# NISSAN DIESEL AMERICA, INC.

DATE: MAY 30, 2000  
MODEL YEAR: 1999 AND 2000  
MODELS AFFECTED: UD1800CS  
BULLETIN #: SC - 124/125  
FILE AT THE END OF THE ENGINE SECTION OF THE TECHNICAL BULLETIN BINDER

VOLUNTARY SAFETY RECALL CAMPAIGNS #00V-124 AND 00V-125:  
1999 AND 2000 MODEL YEAR UD1800CS MODEL VEHICLES FUEL SUPPLY  
HOSE AND FUEL FILTER SUPPORT BRACKET REPLACEMENT

A. RECALL 00V-125: REPLACE THE FUEL FILTER SUPPORT BRACKET

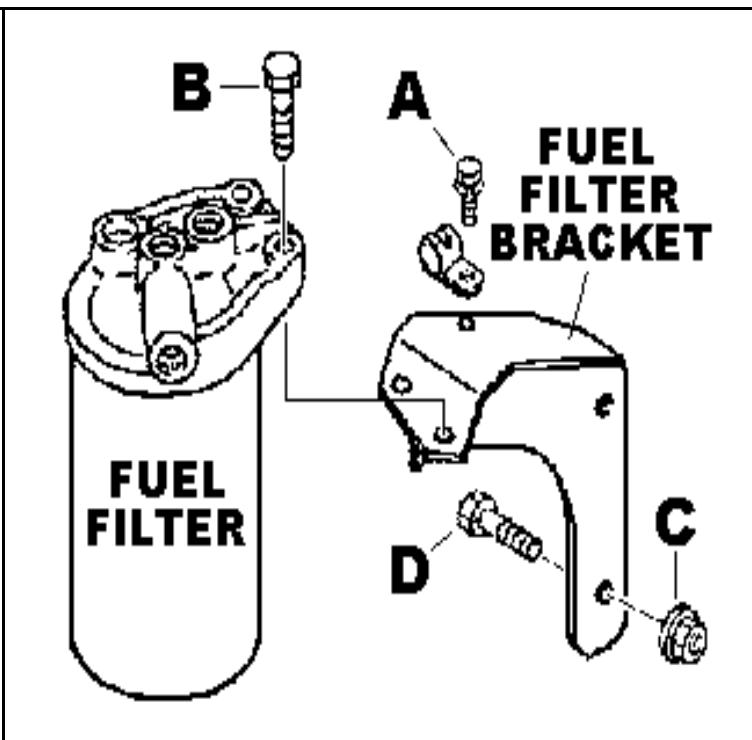
00V - 125: The fuel filter support bracket may crack and break due to vibration, which could allow the fuel filter to separate and lodge on top of the chassis frame and come in contact with the engine assembly.

1. Using a 12 mm wrench, remove the fuel hose clamp mounting bolt "A", as shown in the illustration on the right. Save the clamp and bolt for later use.
2. Using a 14 mm wrench, remove both fuel filter mounting bolts "B". Save the bolts for later use.
3. Using 17 and 14 mm wrenches, remove the nuts and bolts "C" and "D" (2 ea.) that attaches the existing bracket to the cab latching mechanism. Discard the bracket, but save the nuts and bolts.
4. Install the new fuel filter support bracket in the reverse order of its removal. Tighten nuts and bolts as follows:

00V - 125: Replacement of the existing fuel filter support bracket with a new bracket redesigned to prevent cracking and breaking during normal vehicle operation.

**A = 9 ft-lb (13 N-m, 1.3 kgf-m)**

**B = 19 ft-lb (25 N-m, 2.6 kgf-m)**

**C and D = 32 ft-lb (43 N-m, 4.4 kgf-m)**

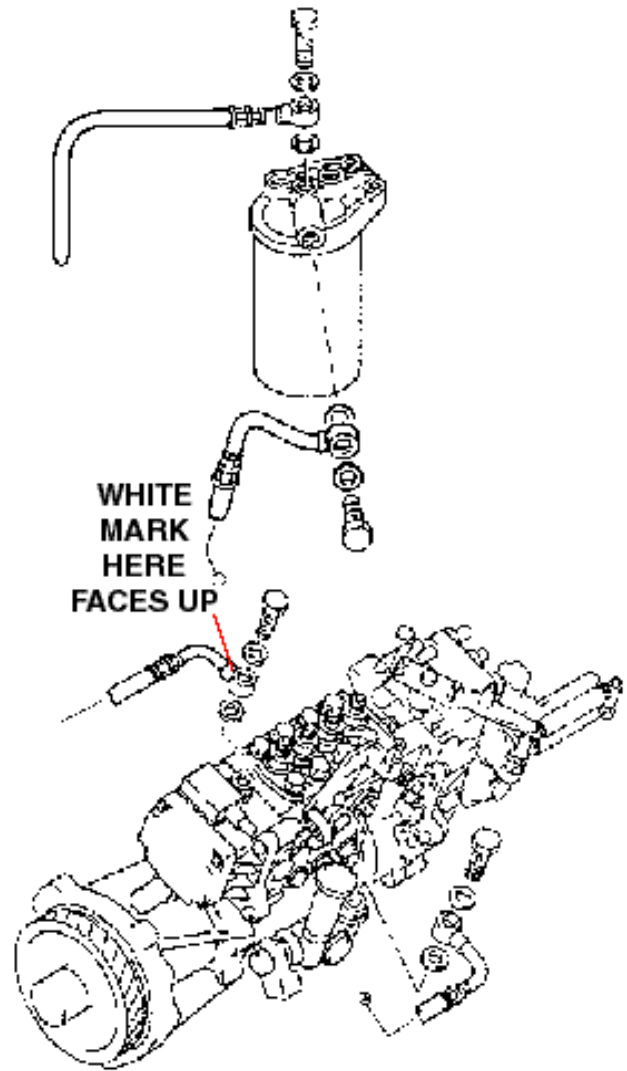
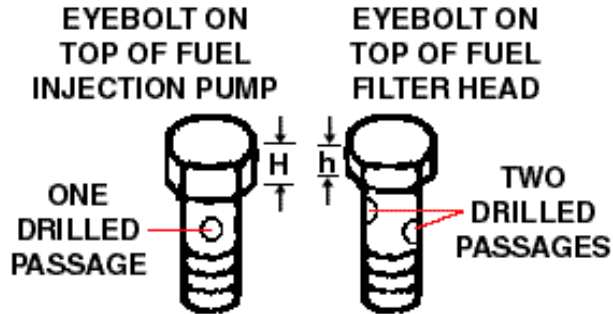
2. Using a 19 mm wrench, remove the eyebolts from the two fuel hoses as shown in the drawing on the right. Save the eyebolts for later use, but discard the hose gaskets.

NOTE: Do not mix up the eyebolt positions.

The eyebolts are *NOT INTERCHANGEABLE*, as shown below. If the eyebolt positions are mixed up, a fuel restriction will occur.

3. Discard the existing fuel hoses. Clean the eyebolts in preparation for installing the new fuel hoses with new gaskets.

4. Using new gaskets with the eyebolts, loosely install both new fuel hoses.

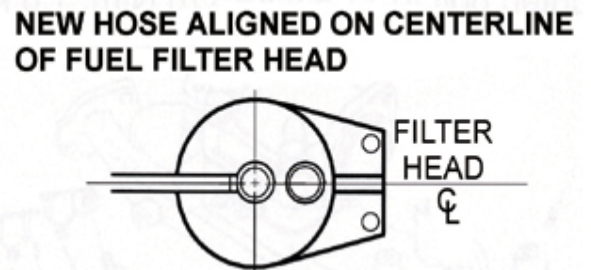
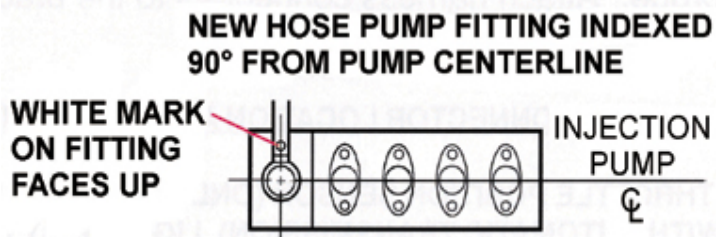
a. Install fuel hose 17551-30D01 (top of injection pump to top of fuel filter) with the white mark on the injection pump fitting facing up as shown below.

b. Index the injection pump fitting perpendicular (90°) to the injection pump centerline as shown below.

c. Index the fuel filter fitting on the centerline of the fuel filter head as shown below.

d. Fuel hose 17550-30D00 (fuel transfer pump to fuel filter) may or may not have indexing tabs on the fittings, as shown below. The tabs are no longer part of the manufacturing process, and they are not required to make a proper hose installation. Either hose may be used.

5. Tighten eyebolts to 18.5 ~ 21.4 ft-lb (25 ~ 29 N·m, 2.5 ~ 2.9 kgf·m) torque while holding the fuel hose fittings in their positions described above.

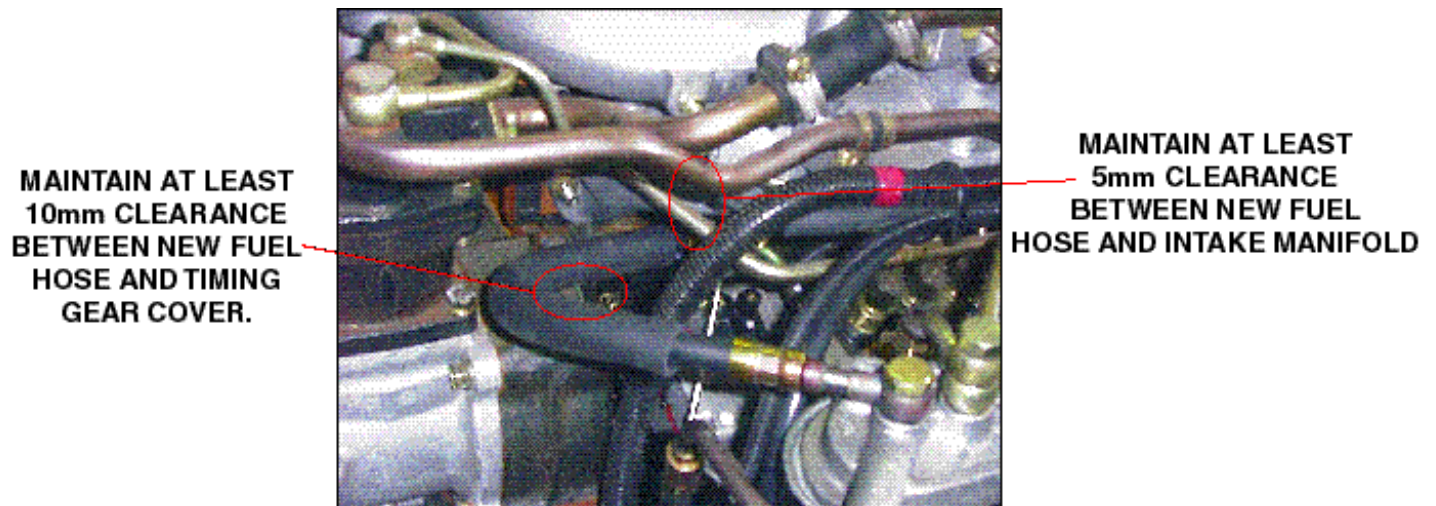
00V - 124: The diesel engine fuel supply hose from the fuel filter to the top of the fuel injection pump is routed in a manner that may allow the hose to come in contact with the engine block.

6. Maintain at least 5mm of clearance between the new fuel hose and intake manifold as shown. Maintain at least 10mm of clearance between the new fuel hose and timing gear cover as shown.

7. If hose clearance is insufficient, loosen the eyebolts and adjust the hose as necessary. Tighten the eyebolts to the proper torque.

C. REPLACE THE ENGINE WIRING HARNESS CONNECTOR MOUNTING BRACKET

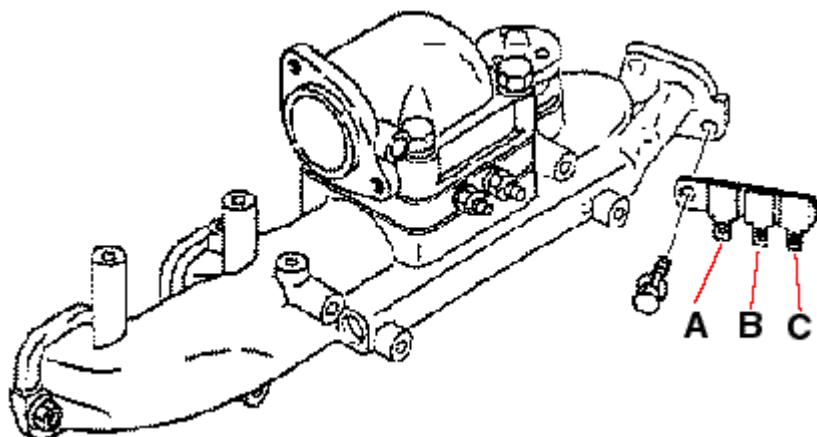
1. Remove the harness connectors from the bracket. Using a 12 mm wrench, remove the existing harness connector mounting bracket from the back of the intake manifold as shown. Save the bolt for later use but discard the mounting bracket.

2. Attach the new bracket to the intake manifold with the bolt removed from the previous step. Tighten bolt to 11.8 ft-lbs (16 N·m, 1.6 kgf·m) torque. Attach harness connectors to the bracket.

**MAINTAIN APPROX. 25mm CLEARANCE BETWEEN HARNESS AND FUEL HOSE**

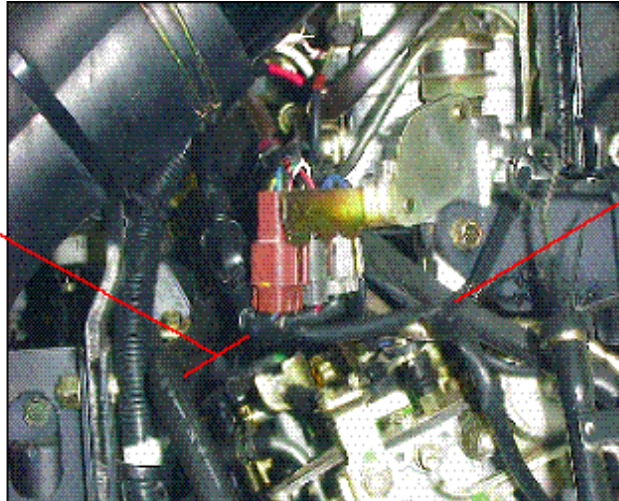
3. Adjust harness tie as necessary to provide sufficient slack in wiring harness and approx. 25mm of clearance between the harness and the fuel hose as shown below.

#### D. INSTALLATION OF FICD VACUUM HARNESS CLAMP

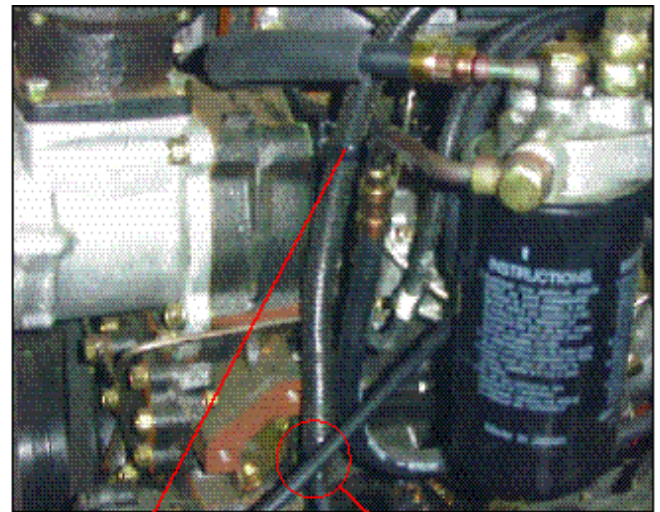
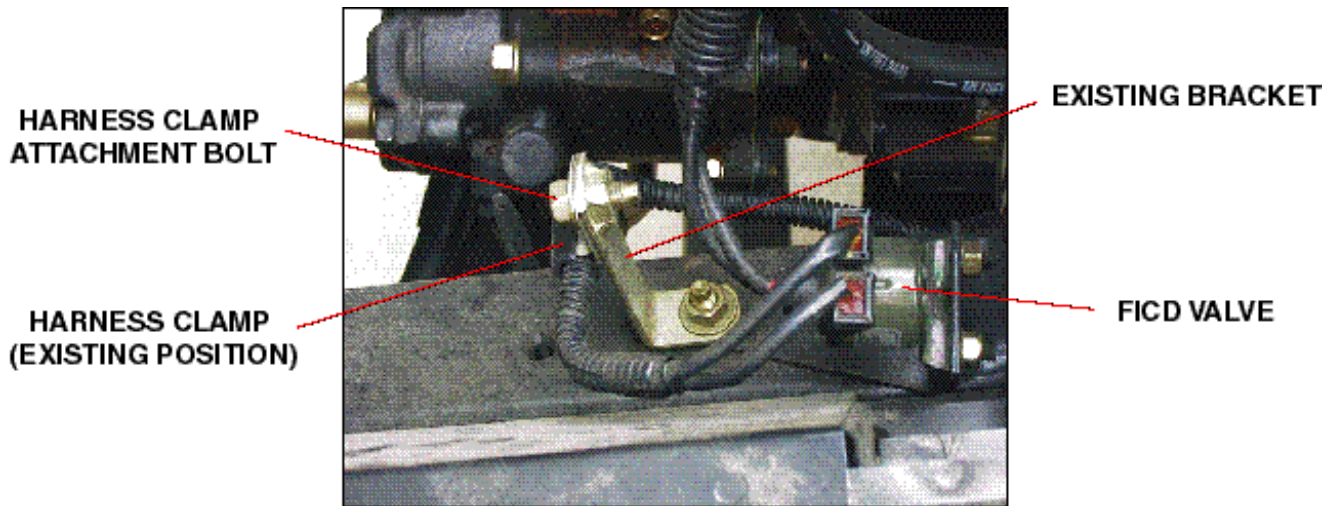
1. Install the new FICD vacuum harness clamp on the air compressor nut and bolt, as shown below, with the clamp arms facing forward.

**INSTALL NEW FICD VACUUM HARNESS CLAMP ON AIR COMPRESSOR NUT AND BOLT WITH THE CLAMP ARMS FACING FORWARD**

**BEND CLAMP ARMS AROUND THE FICD VACUUM HARNESS ...**

**... TO HOLD IT AWAY FROM THE ACCELERATOR CABLE**

2. Bend the clamp arms around the FICD vacuum harness to hold it away from accelerator cable and the fuel hose. Adjust the vacuum harness as necessary to provide sufficient slack.

## E. REPLACEMENT OF FICD VALVE HARNESS MOUNTING BRACKET

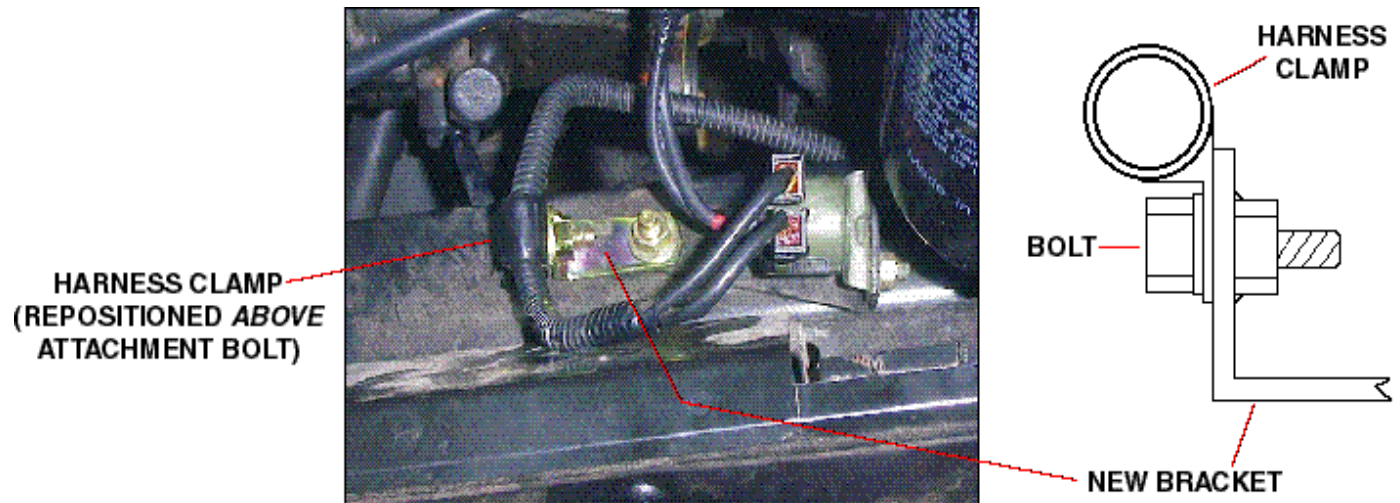
1. Using a 12 mm wrench, remove the bolt that attaches the wiring harness clamp to the bracket. Remove the clamp from the harness. Save the clamp and bolt for later use.
2. Remove the bracket mounting nut and bolt. Discard the bracket but save the nut and bolt for later use.

3. Install the new FICD harness mounting bracket in reverse order of its removal. Remove and reverse the position of the harness clamp so that it mounts above the attachment bolt as shown below. Torque fasteners to 9 ft-lbs (13 N-m, 1.3 kgf-m).
